SERVICE BULLETIN

SUBJECT: PN 369D21400-501 MAIN ROTOR LEAD-LAG ELASTOMERIC DAMPER ASSEMBLY- INTERNAL MODIFICATION AND REIDENTIFICATION

MODELS AFFECTED: 500 D Model 369D Series Helicopter Serial No. 0003D thru 0555D equipped with PN 369D21400-501 Elastomeric Dampers

Figure 1. Main Rotor Damper - Internal Modification and Reidentification, M50452

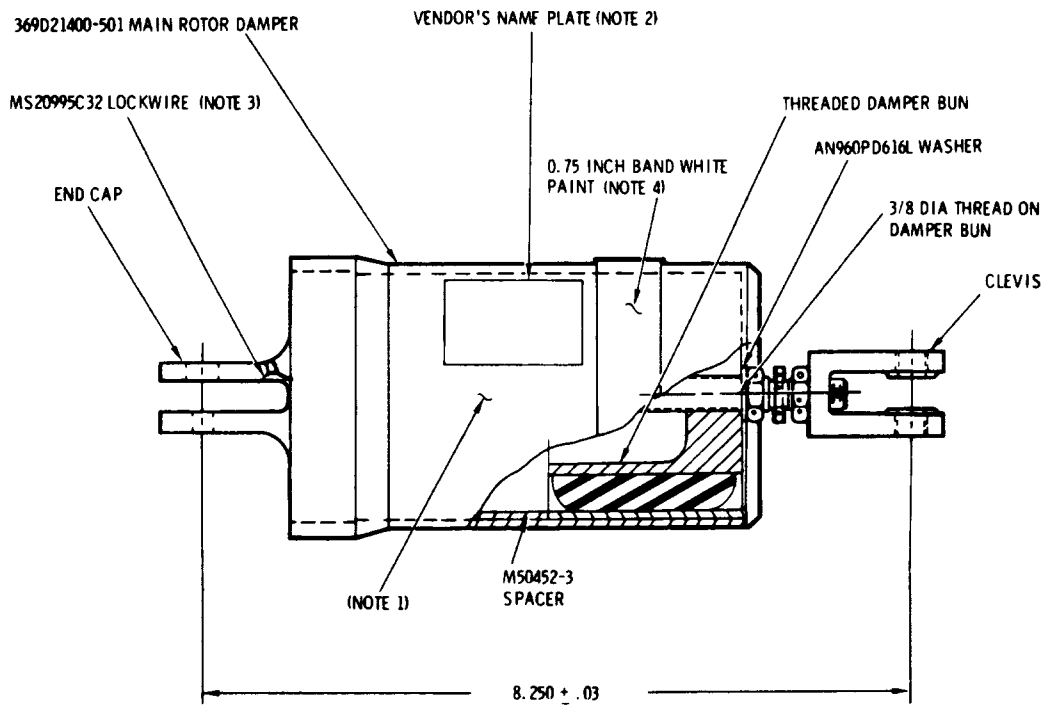
PREFACE: The information given in this Service Information Notice provides instructions for reworking the PN 369D21400-501 Elastomeric Main Rotor Damper Assemblies in order to reduce operating stresses in the main rotor blade retention straps. The damper stiffness is reduced by removing one of the elastomeric components inside the damper and replacing it with an aluminum spacer.

d. Reinstall threaded damper bun, then install new M50452-3 spacer as shown in Figure 1. Install damper bun, -3 spacer and damper end cap with wet zinc chromate primer.

e. Using special torque wrench adapter, install and torque damper cap to 800 to 840 inch-pounds and safetywire as shown. Safetywire to clear slot in cap.

f. Ink stamp Part No. M50452 on damper as shown, and add suffix letter "M" to vendor part number on name plate. Also paint damper housing with 0.75-inch band of white paint to identify modified damper assembly.

Figure 2. Field Fabrication - Torque Wrench Adapter and Damper Holding Tool

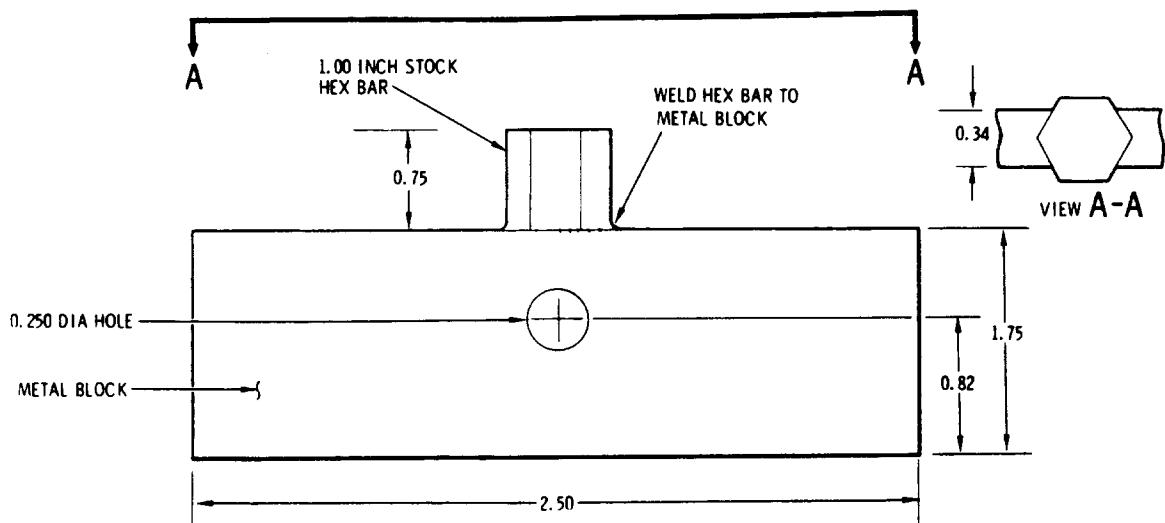
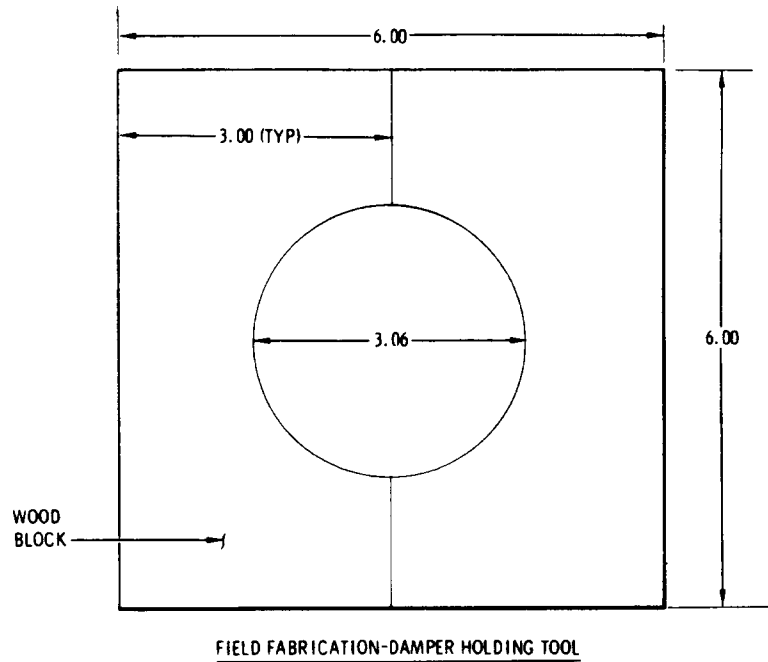
1. Field fabricate special holding tool (see Figure 2); use holding tool when securing damper in vise, to preclude damage to damper housing.
2. Field fabricate torque wrench adapter (see Figure 2); use adapter when removing and torquing damper cap, to preclude damage to damper cap ears. Insert bolt to secure tool between damper ears; secure bolt with nut.
